Village of Mukwonago
Notice of Meeting and Agenda

PLAN COMMISSION MEETING
Tuesday, October 13, 2020

- 5.2 Discussion and recommendation to Village Board on **RESOLUTION 2020-55** a Resolution to approve Site Plan and Architectural Review for Malcolm Drilling, Applicant; 120 Hill Ct; Parcel #A486800002

- 5.3 Discussion and recommendation to Village Board on **RESOLUTION 2020-56** a Resolution to approve Site Plan and Architectural Review for Grey Fox Holdings, Applicant; 704 Cardinal Ln Unit 1; Parcel MUKV 2091-989-098; 704 Cardinal Ln Unit 2; Parcel MUKV 2091-989-099; 704 Cardinal Ln Unit 3; Parcel MUKV 2091-989-100; 704 Cardinal Ln Unit 4; Parcel MUKV 2091-989-101.
[Staff report for 704 Cardinal Ln.pdf](#)
[RESOLUTION 2020-56 SPAR 704 Cardinal Ln.pdf](#)

Sheet Title
ELEVATIONS
FRONT
REAR

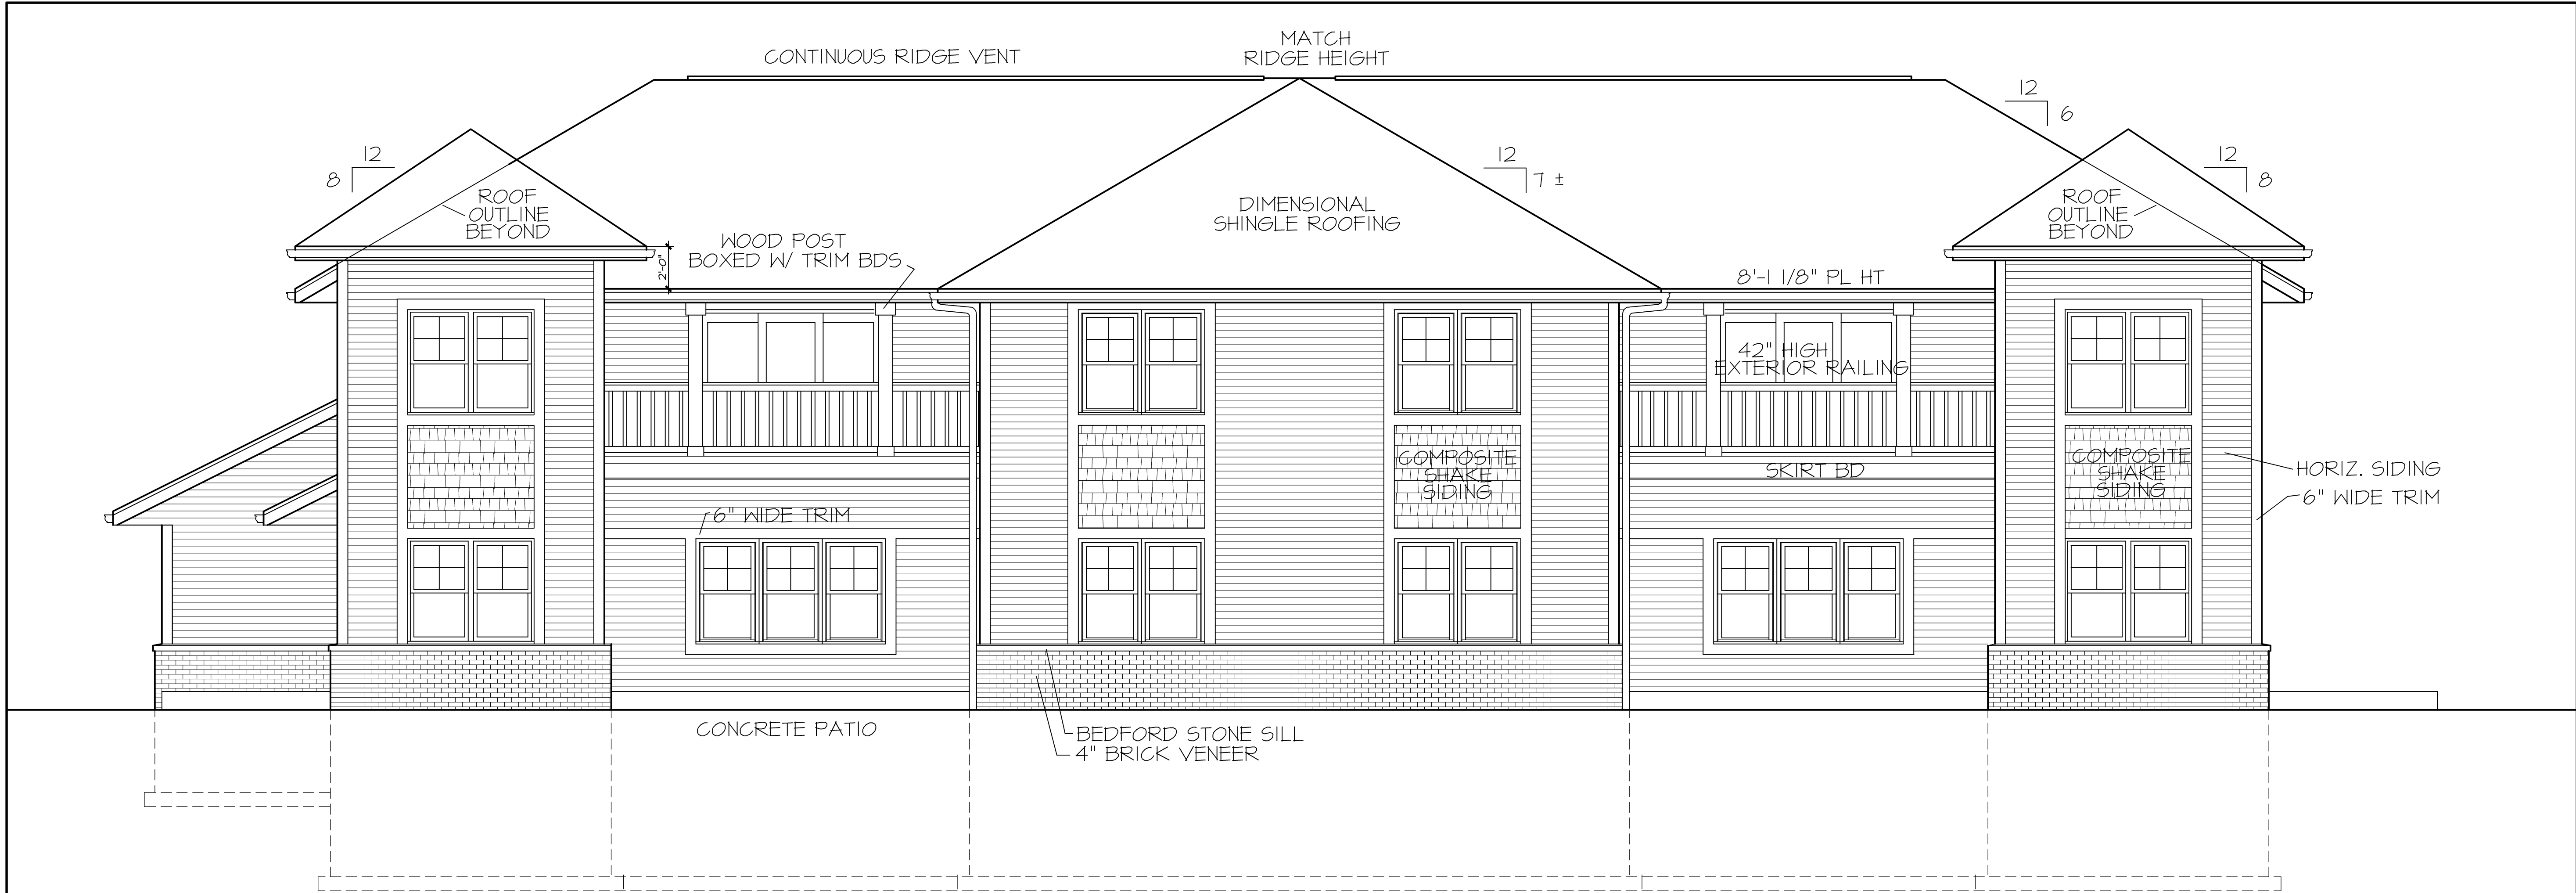
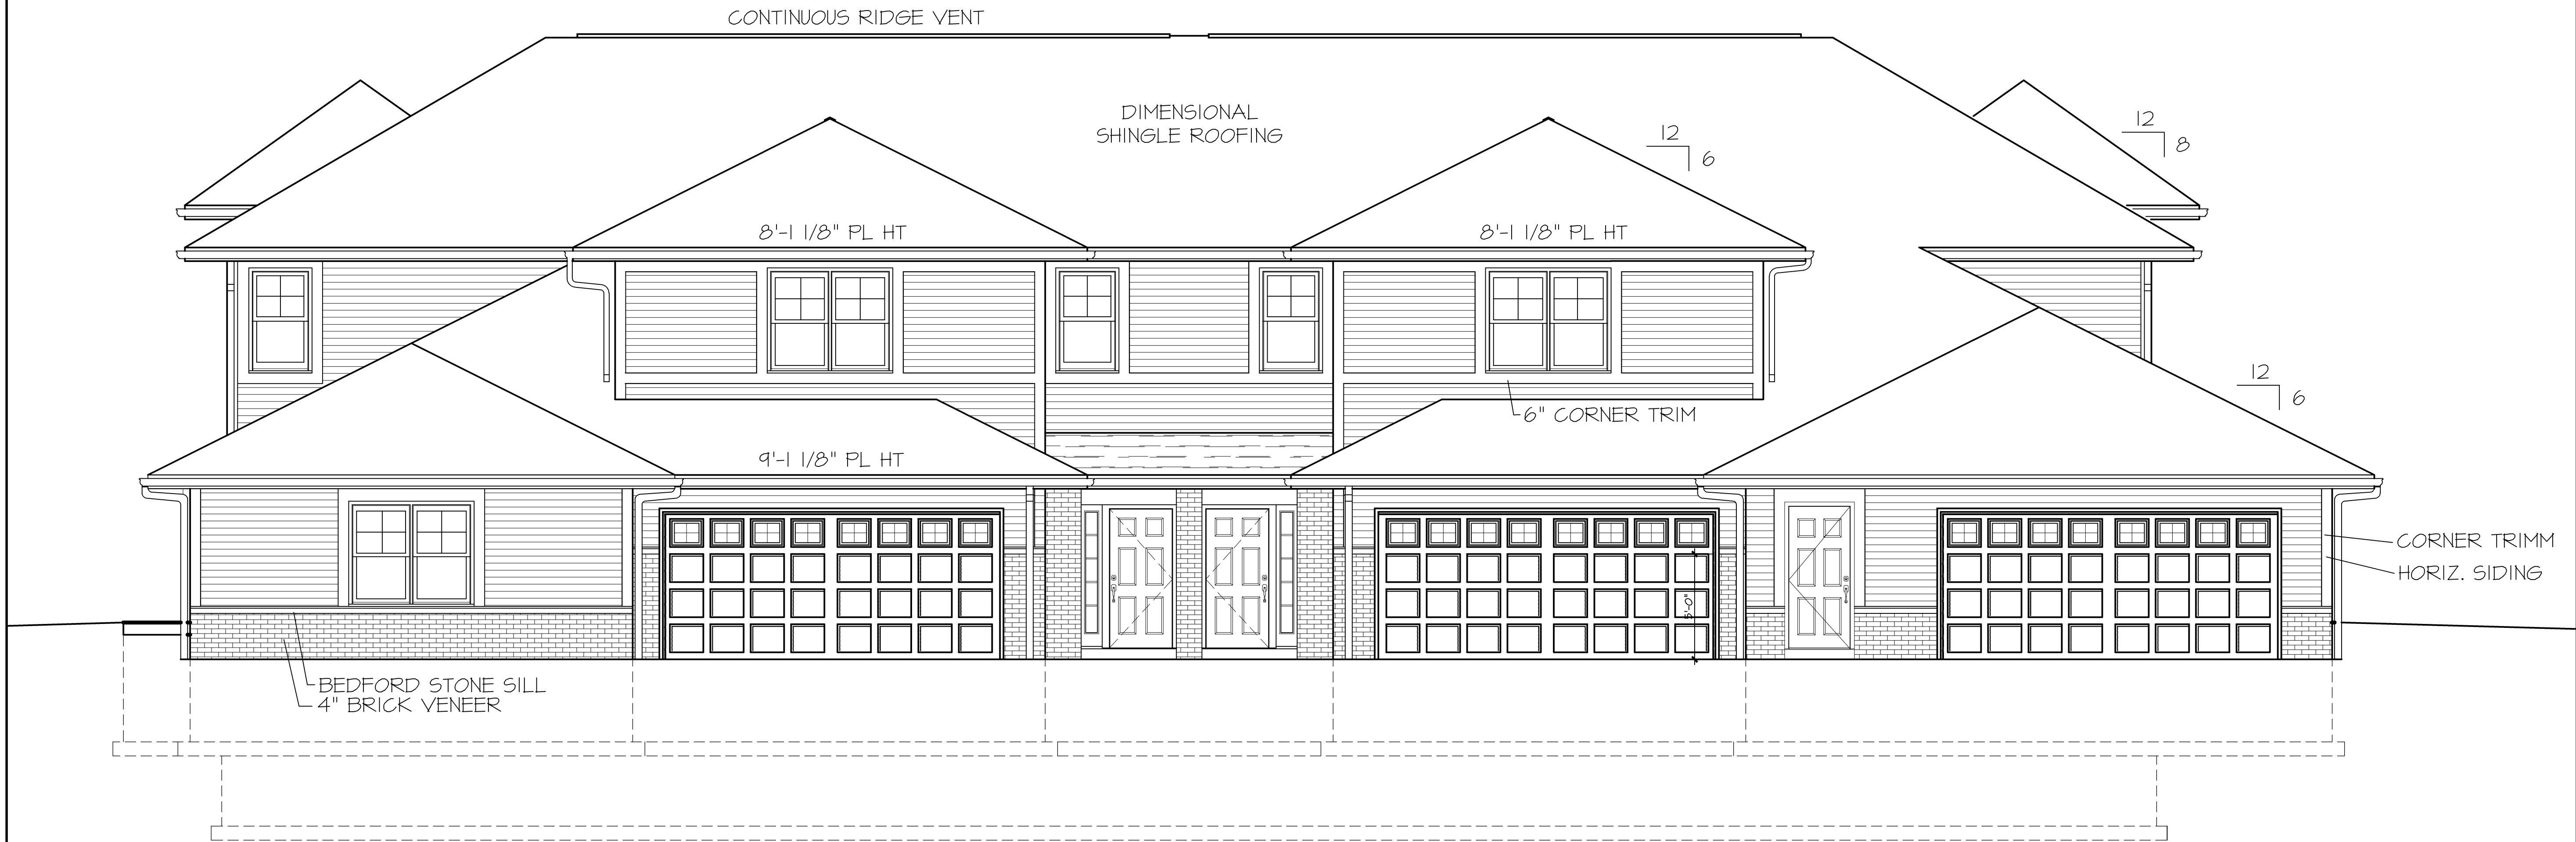
1. **Garage door placement.** The original design showed 2 doors facing Cardinal Lane, with one facing north, and the other facing south. The new design shows 3 doors facing Cardinal Lane and the other one would face to the internal road on the north.
2. **Exterior patios.** The original design had stacked balconies (first floor and second floor). The proposed plans only show a balcony on the second-floor units.
3. **Footprint** The footprint of the proposed design is slightly different than the original design. As such, the developer will need to prepare a condo amendment and obtain the approval of the same.

Exterior materials on this building will match the materials on the existing condo units. The developer will bring color samples to the Plan Commission meeting.

SHEET TITLE
LANDSCAPE PLAN
Revised Plan.
Approved 2/21/19.
Zoning Administrator

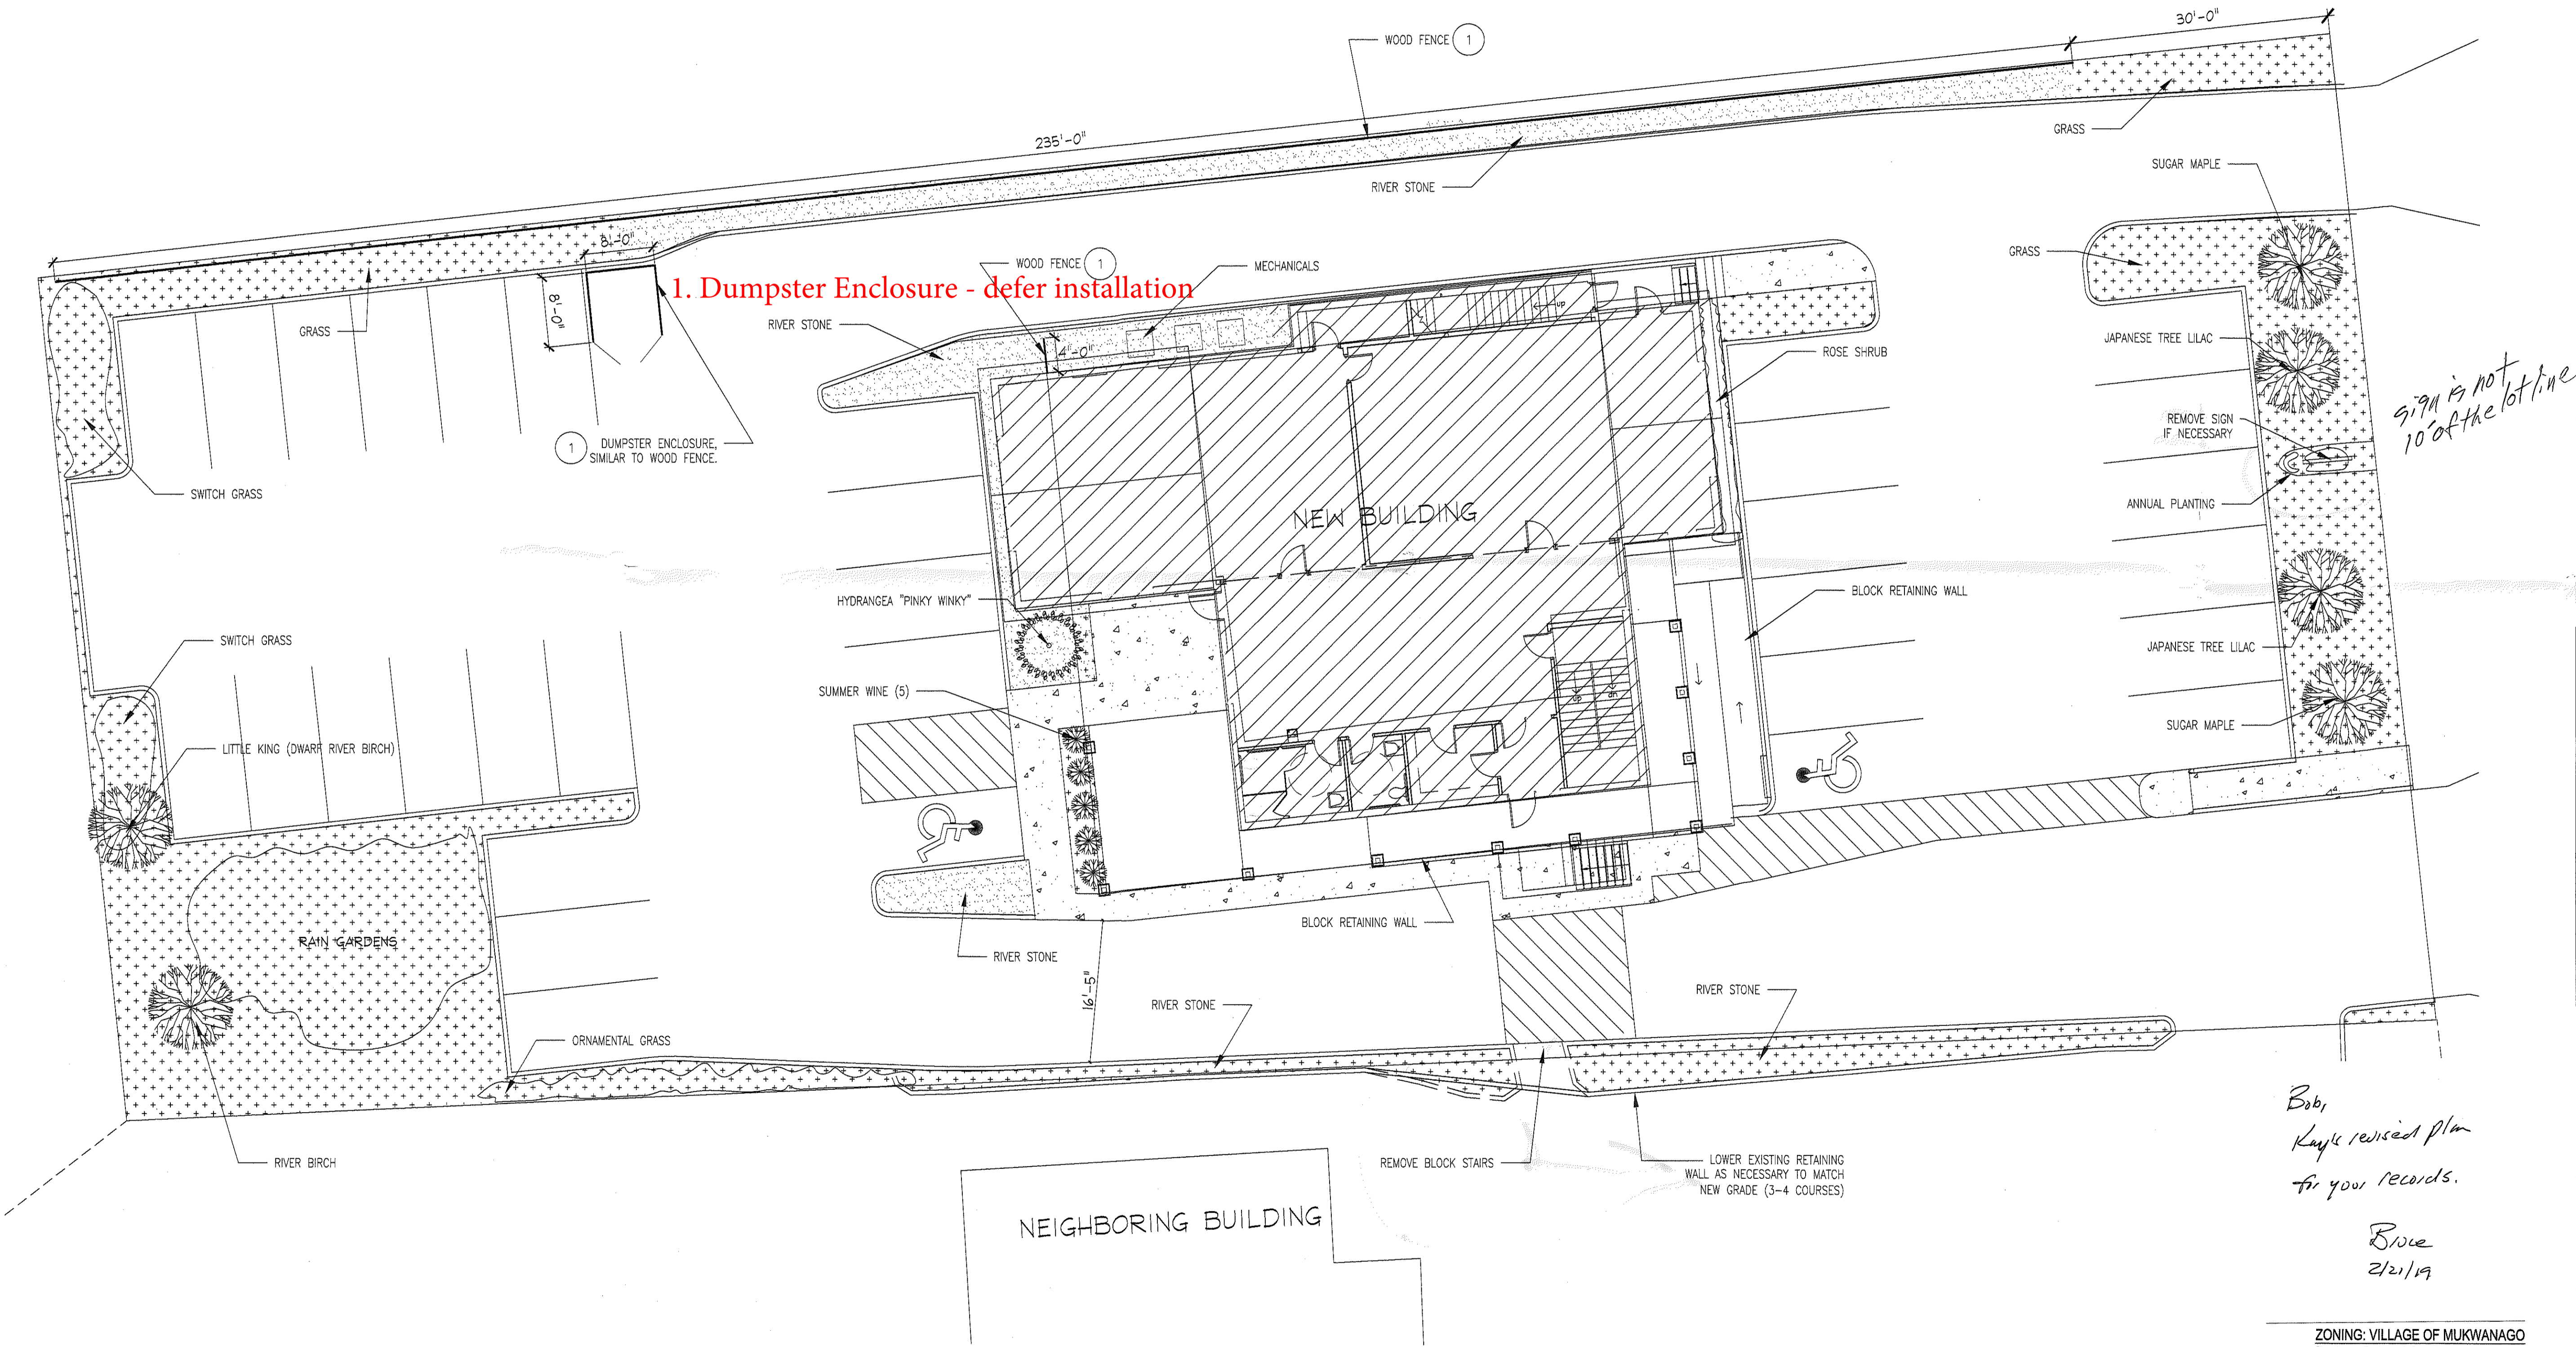
WHEREAS, pursuant to Section 100-601 of the Zoning Code, an application to amend Resolution 2018-81 site plan and architectural review has been filed for the approval to not construct a trash enclosure, application was filed in the office of the Village Clerk, Village of Mukwonago, Wisconsin, and

1. The property owner is not required to install the trash enclosure as depicted on the approved site plan at this time.
2. The property owner must however install the enclosure when a dumpster is need to handle the trash and recyclables. In this regard, the owner will do so upon written request of the Plan Commission, consistent with the timeline established in such notice.
